Re: Initial Submission Review: Prairie Point Site Plan No 5 – Site Plan and Plat and Plat

Application Number: DA-1609-29

Case Numbers: 2024-4022-00; 2024-3049-00

PRAIRIE POINT SUBDIVISION FILING NO. 5
SITE PLAN
UTILITY PLAN INDEX

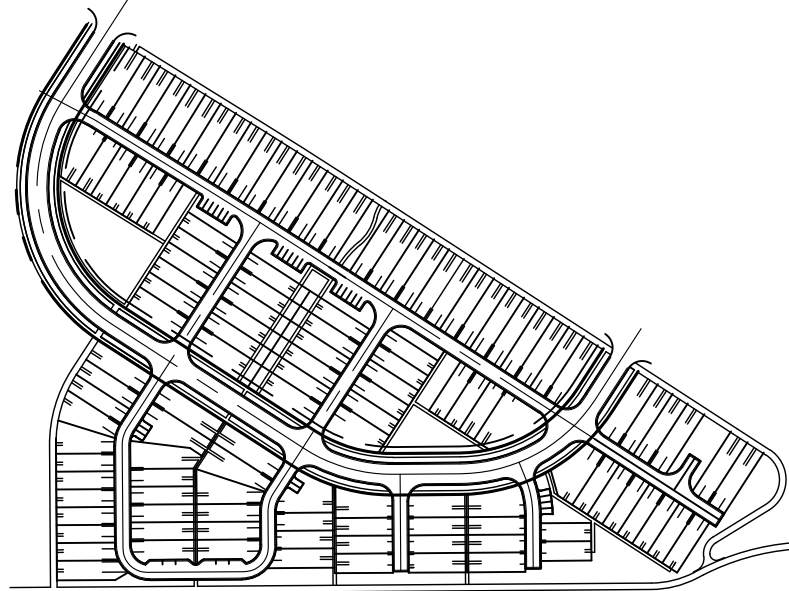
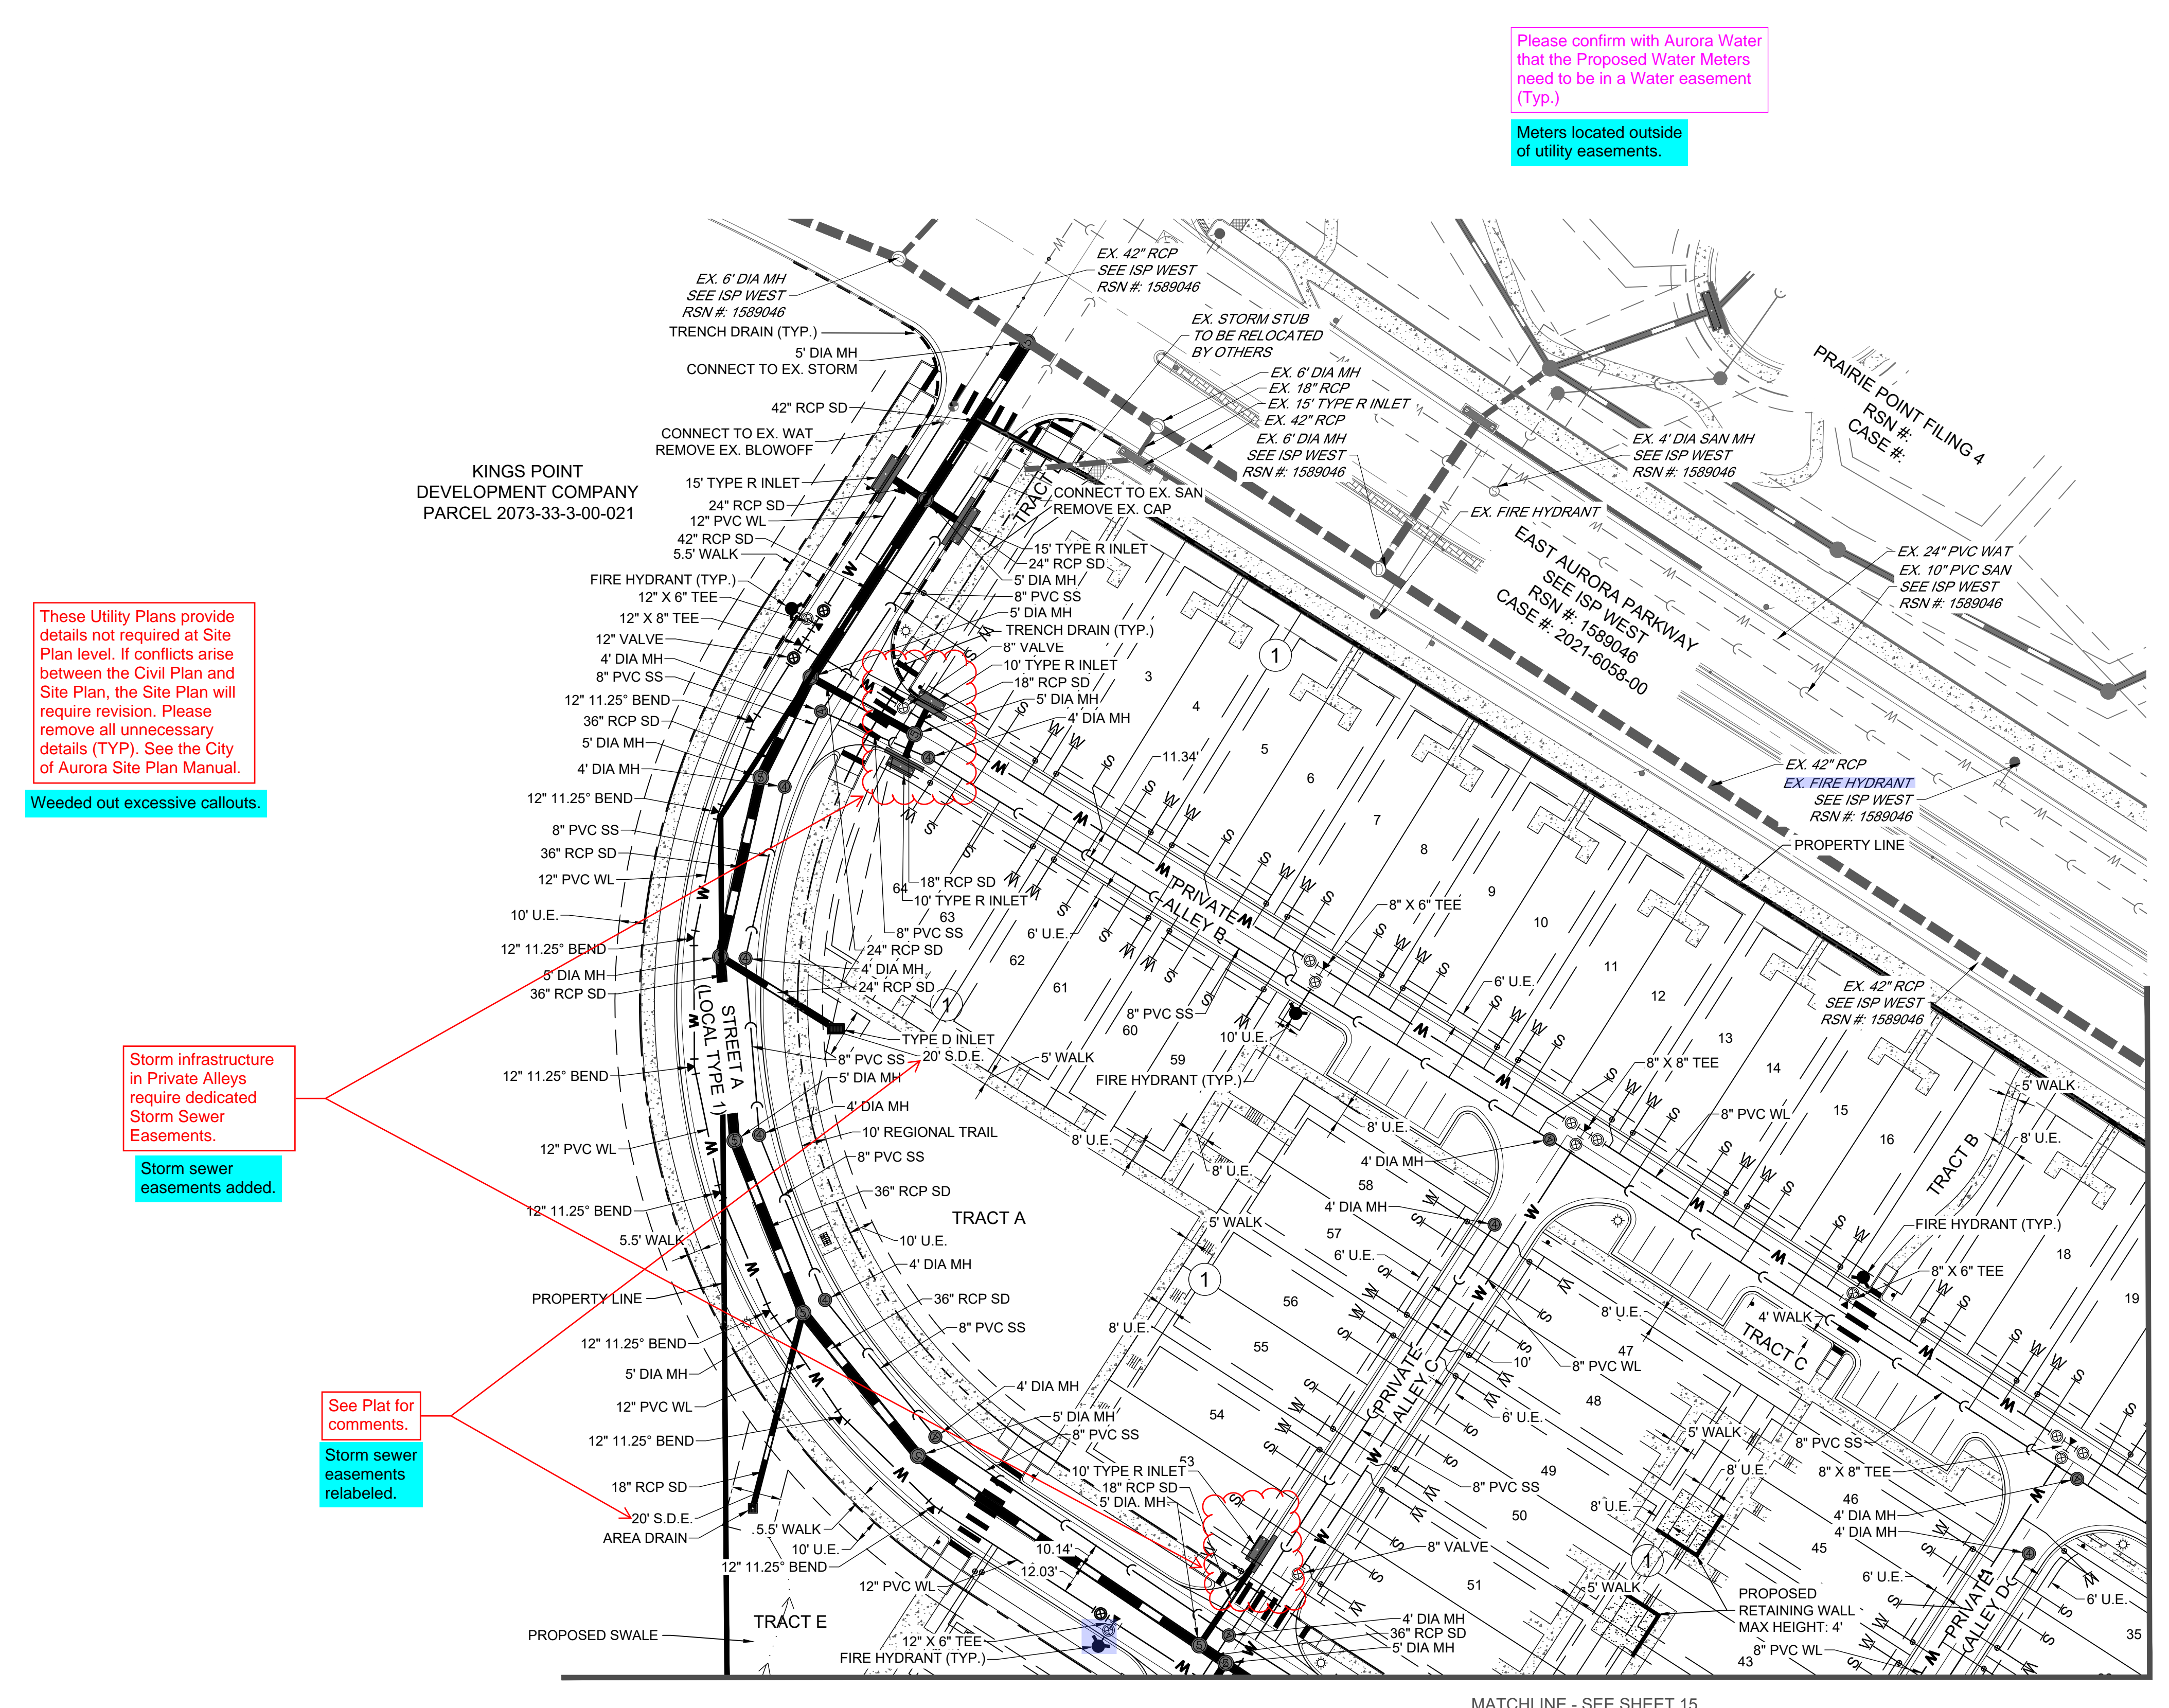
Please provide a Fire Hydrant Symbol and Legend on the Utility Plans. TYP

These Utility Plans provide details not required at Site Plan level. If conflicts arise between the Civil Plan and Site Plan, the Site Plan will require revision. Please remove all unnecessary details (TYP). See the City of Aurora Site Plan Manual.

Legend updated.

PRAIRIE POINT SUBDIVISION FILING NO. 5
SITE PLAN
SIGNAGE AND LIGHTING INDEX

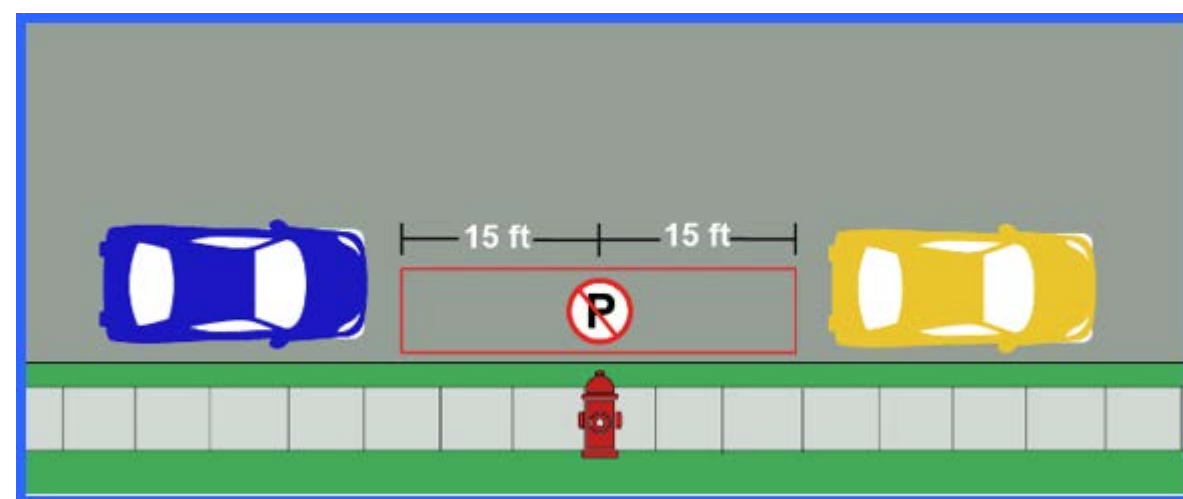
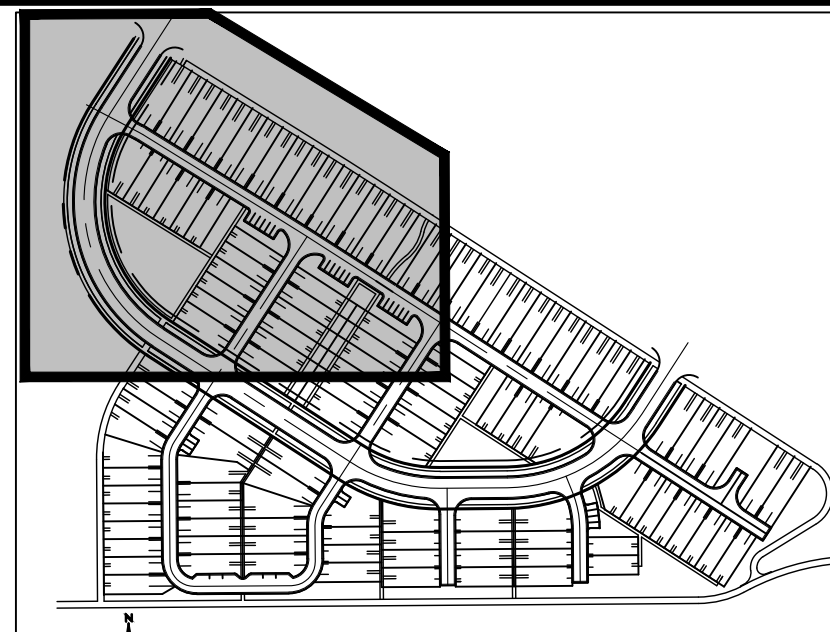
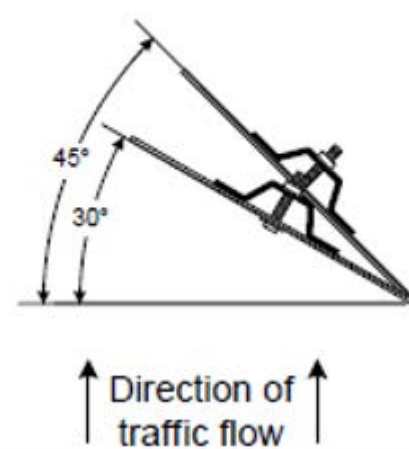
Please include the No Parking Sign Locations for within 15 feet of either side of the Fire Hydrants and include sign as part of sign package.

- Mailbox doesn't meet COA requirements.

Add dimension to parking spaces.

Signage added.

Mailboxes have been relocated to accommodate COA standards.

Dimensions added.

LP.2
SHEET 22

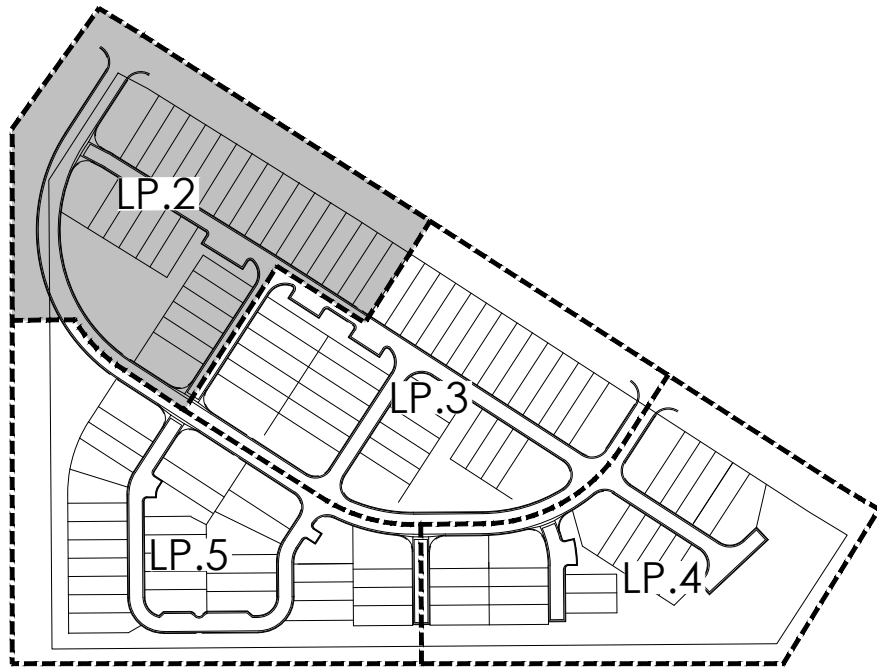
The grasses in the curbside landscape must be 5 gallon. This should be SHP #5 (typical).
RESPONSE: #5 ADDED TO LABEL TYP.

If the trees are deficient on this side of the street due to the mid-block crossing, you should note that in the landscape table for the curbside landscaping. You should also subtract that distance from the street and not count that towards their required curbside landscaping for street trees.
RESPONSE: Noted, 50' from each side of a mid-block crossing will be subtracted from the total curbside length. The tree requirement will be updated accordingly.

Demonstrate how the duplexes along E Aurora Parkway meet private open space requirements. The open spaces must be 180 sf, have minimum 10 ft dimensions, and have a 6ft x 8 ft min porch or deck when counted in the front yard.
RESPONSE: 180 SF OF PRIVATE OUTDOOR SPACE IS REPRESENTED BY THE HATCH BELOW. ALL PORCHES MEET THE MINIMUM DIMENSIONS.

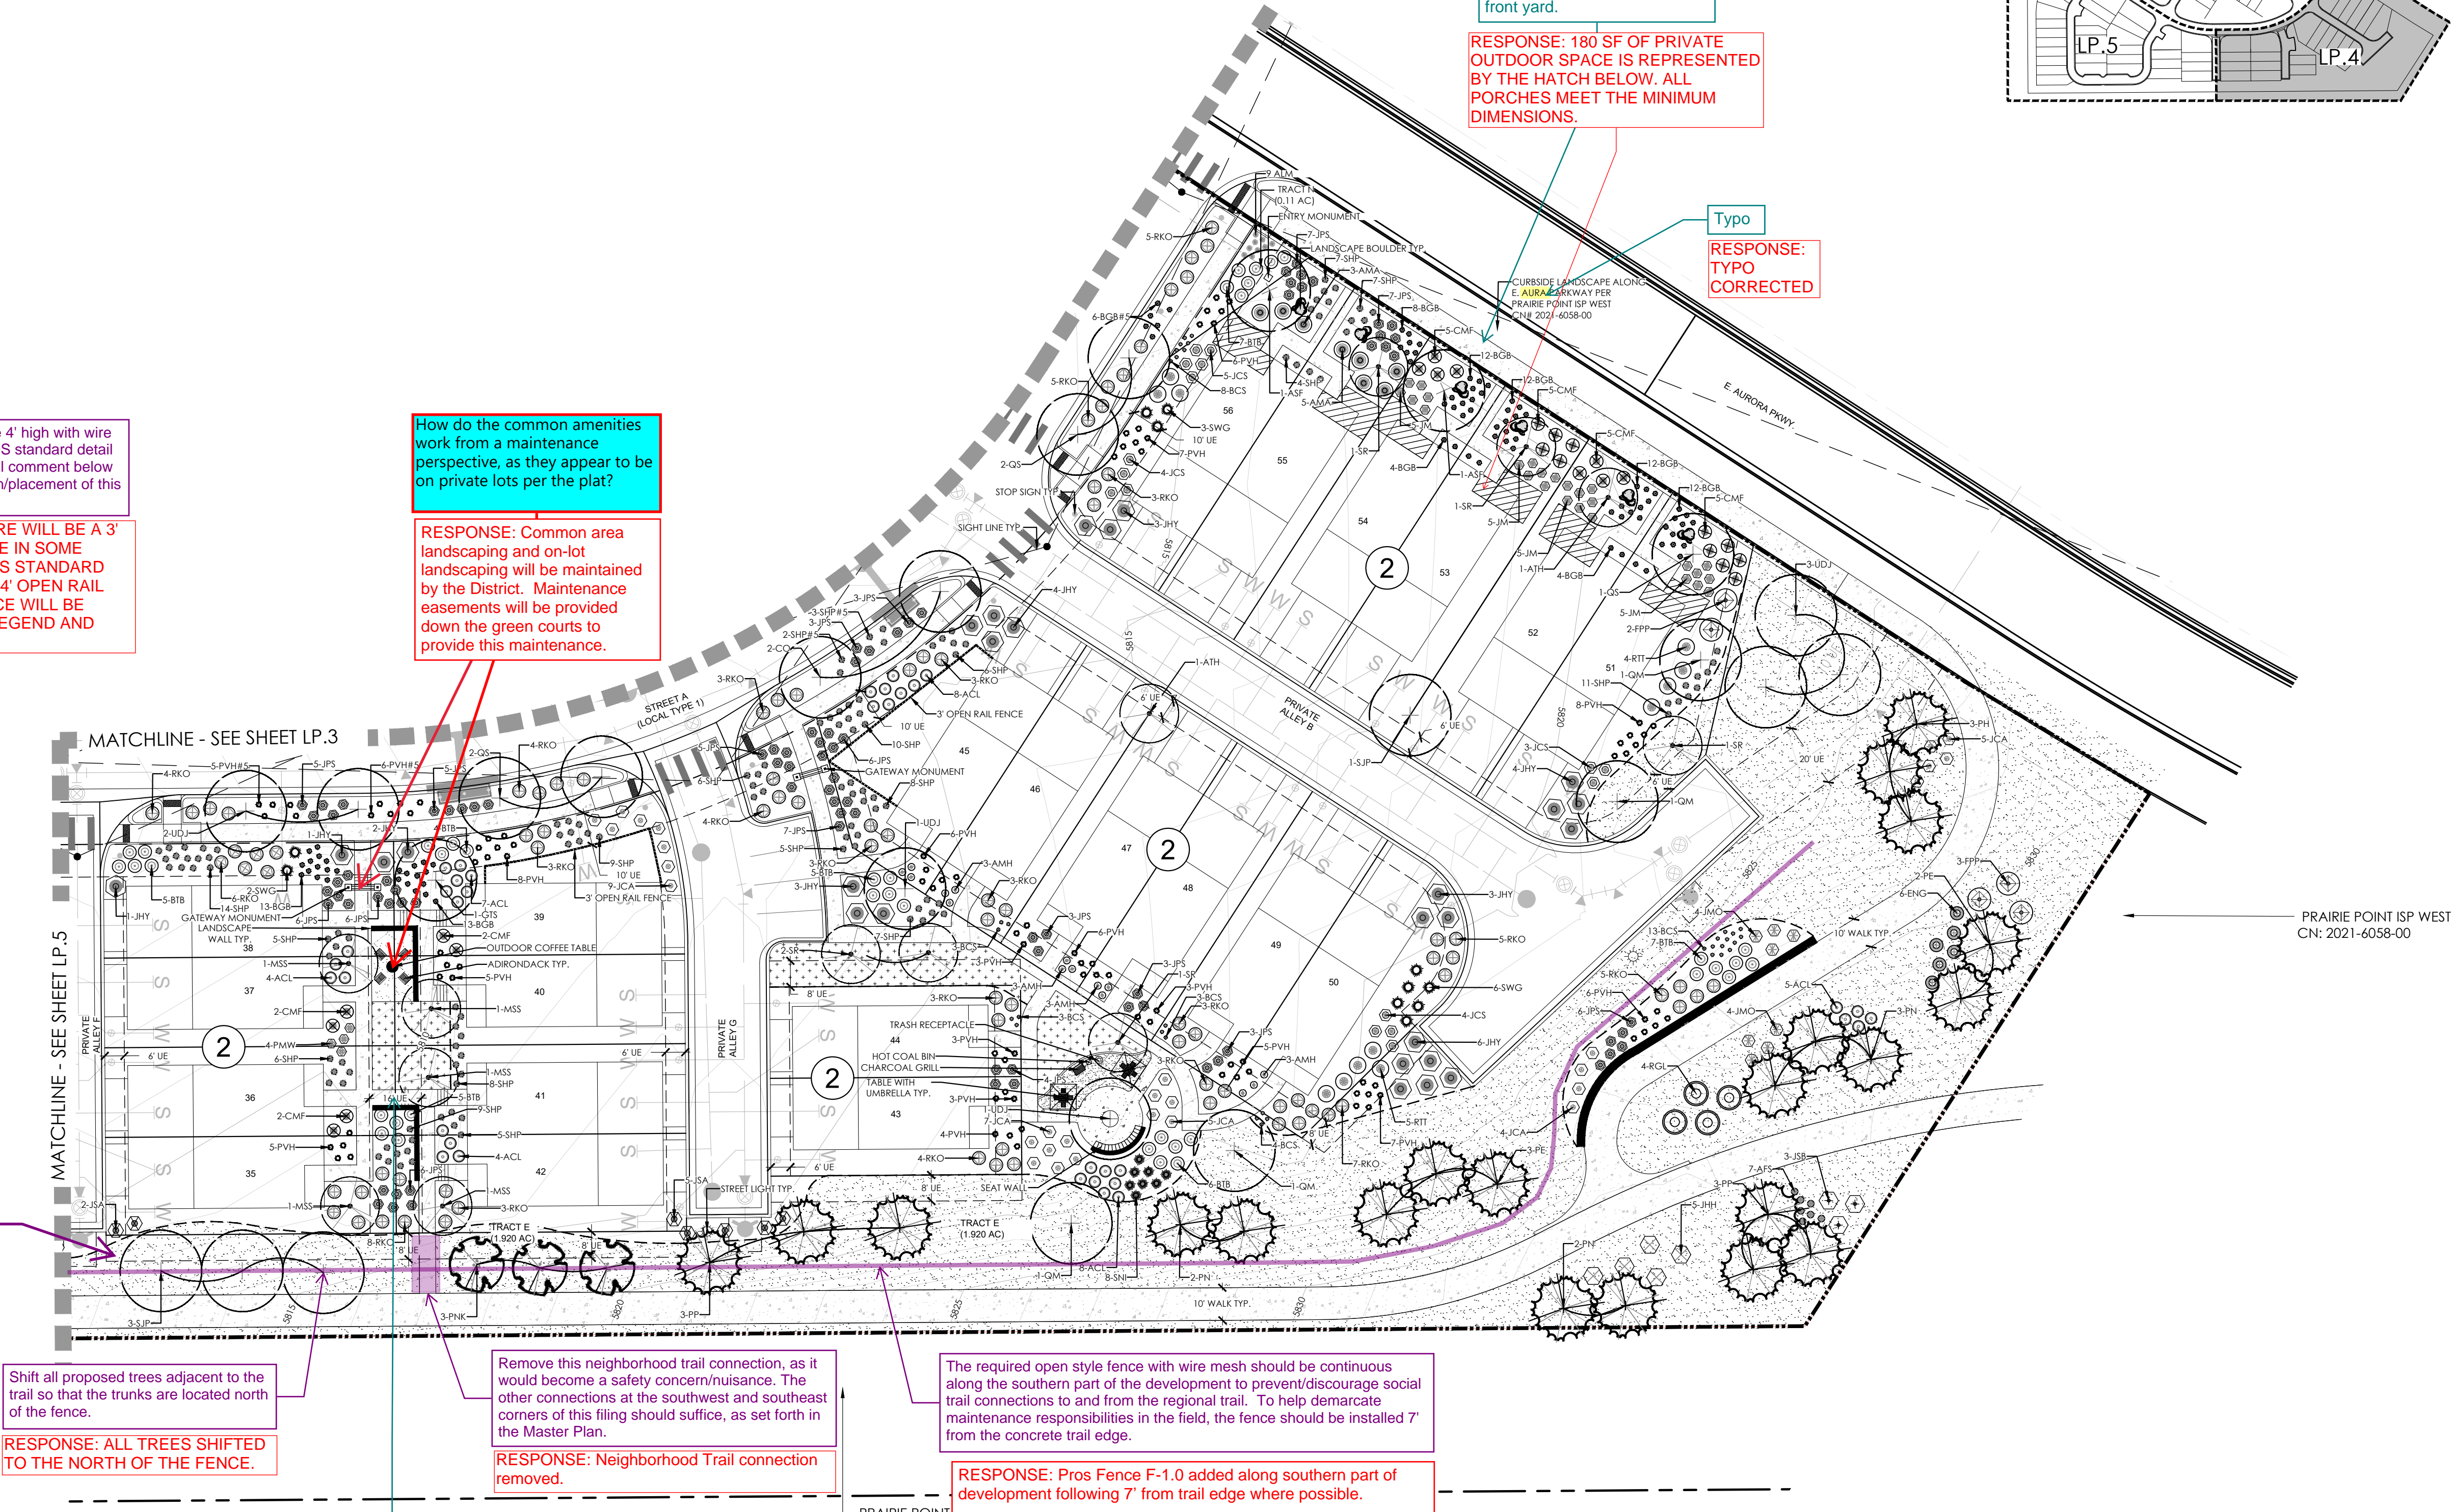
It is noted that the width of the special landscape buffer does not comply with the 25' requirement. PROS supports an adjustment due to the impact of the regional trail, provided the landscaping in the buffer north of the fence complies as best as possible with the 1 tree and 10 shrubs per 30 linear feet planting requirement to achieve suitable screening.

The fence should be 4' high with wire mesh to match PROS standard detail F-1.0. See additional comment below regarding installation/placement of this fencing.

RESPONSE: BOULDERS ADDED TO ALL LOTS.
